Product Change Notice (PCN)

PCN Number: PCN-0455122R-01

Product(s) Affected: *PJ-068B-SMT-TR*

PREVIOUS CUI DEVICES DETAIL / IMAGE NEW CUI DEVICES DETAIL / IMAGE

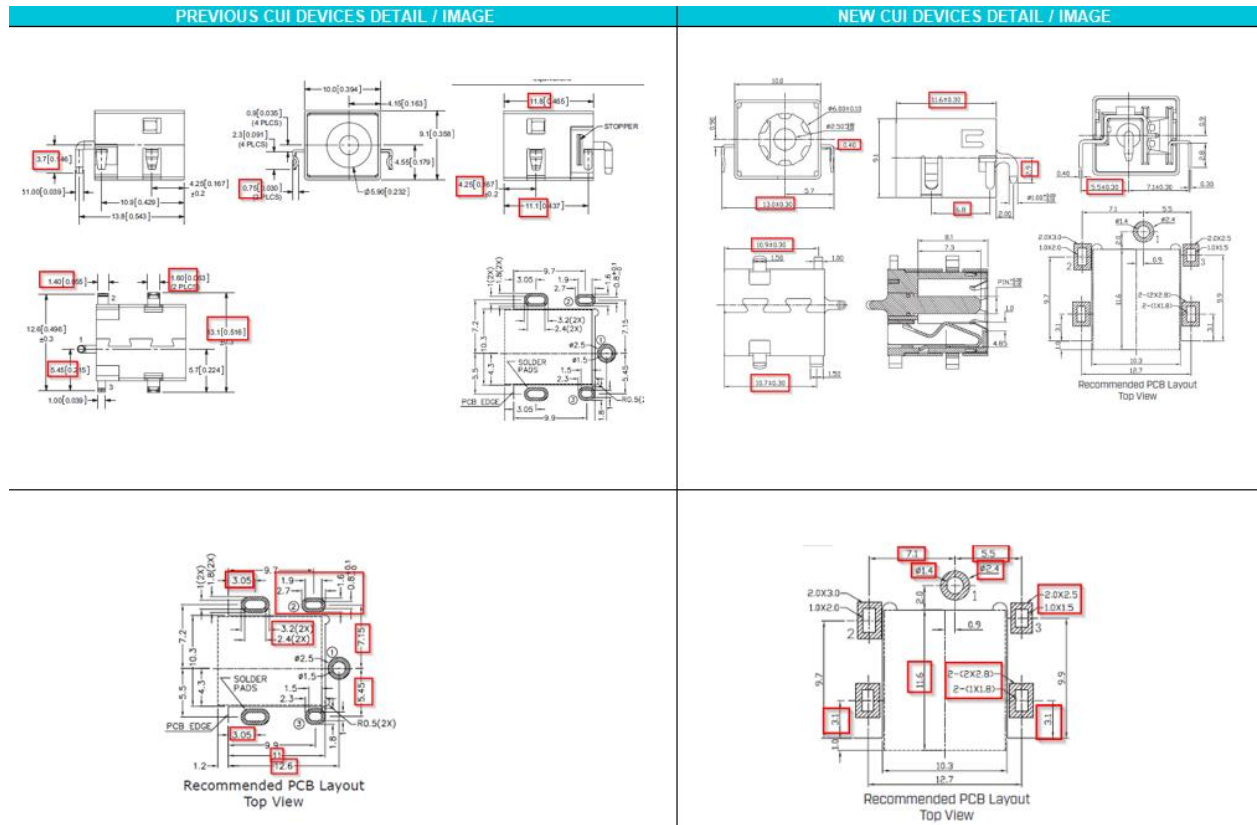
Description of Change: *Minor Housing and footprint differences. Material Change on the housing and terminals. See image Below*

MATING PLUG
Jack Insertion Depth: 8.2 mm

MATERIAL	PLATING
center pin	brass	silver
terminal 1	brass	silver
terminal 2	copper alloy	silver
terminal 3	brass	silver
stopper	cold rolled steel	nickel
shield-A	brass	nickel
shield-B	stainless steel	
plastic	PA6T or equivalent

MATING PLUG
Jack Insertion Depth: 8.1 mm

DESCRIPTION	MATERIAL	PLATING/COLOR
center pin	zinc alloy	nickel
terminal 1	zinc alloy	nickel
terminal 2	bronze t=0.30	silver
terminal 3	brass t=0.40	silver
shield-A	iron t=0.30	nickel
shield-B	SUS301 t=0.10	
housing	PABT (UL94V-D)	black
